Subject: AP1000 COL Response to Request for Additional Information (TR 106)

In support of Combined License application pre-application activities, Westinghouse is submitting a response to the NRC request for additional information (RAI) on AP1000 Standard Combined License Technical Report 106, APP-GW-GLN-106, "Mechanical System and Component Design Updates". This RAI response is submitted as part of the NuStart Bellefonte COL Project (NRC Project Number 740). The information included in the response is generic and is expected to apply to all COL applications referencing the AP1000 Design Certification.

RAI Response Number: RAI-TR106-CIB1-04  
Revision: 0

**Figure 2.** Corrosion performance of various stainless steels in boric acid environments.  
(source – Corrosion Handbook, Ninth Edition, Outokumpu Stainless Oy, 2004)

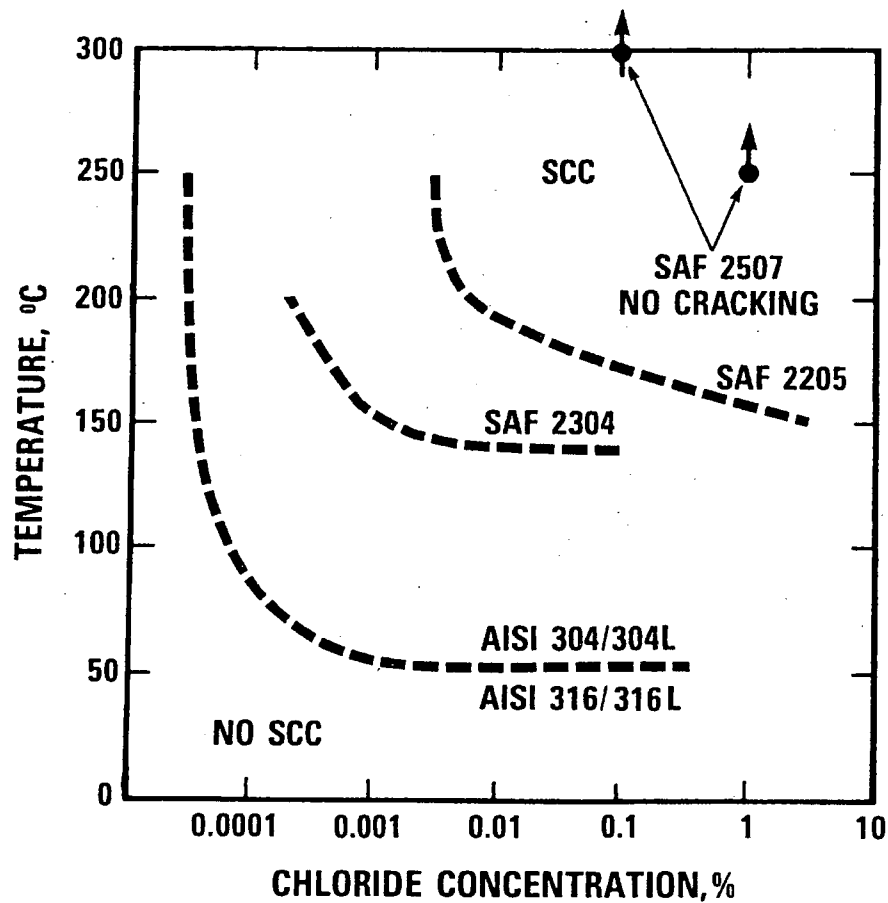
1. It appears, from the applicant's response, that corrosion testing of LDX 2101® and weld filler metals 2304 and 2209 has not been performed to justify the use of these materials in a borated water environment. In addition, the applicant did not provide a technical justification for the use of these materials in the intended application, therefore, the staff requests that the applicant provide a technical justification for the use of the aforementioned materials. In addition, provide a description of the corrosion testing plan that will be used and discuss why the testing plan is adequate to ensure that the materials will not be subject to general corrosion, stress corrosion cracking or other forms material degradation due to corrosion for the life of the plant.

2. The staff notes that weld filler materials 2304 and 2209 are not matching filler materials for LDX 2101® which suggest that these filler metals would have different properties. Given that a matching filler material (Avesta LDX 2101) is currently available, provide a technical justification for using filler materials that are designed to weld duplex stainless steels other than LDX 2101®.

Although corrosion testing with welded LDX 2101 stainless steel samples is just being initiated, there are research data and producers' technical information that show the LDX 2101 will be very resistant in borated water environments. For example, similar duplex stainless steels such as type 2304 and 2205 show very low general corrosion rates in boric acid and bromide salt environments (see Figures 1 and 2), which indicates that duplex stainless steels, in general, perform very well in borated environments.
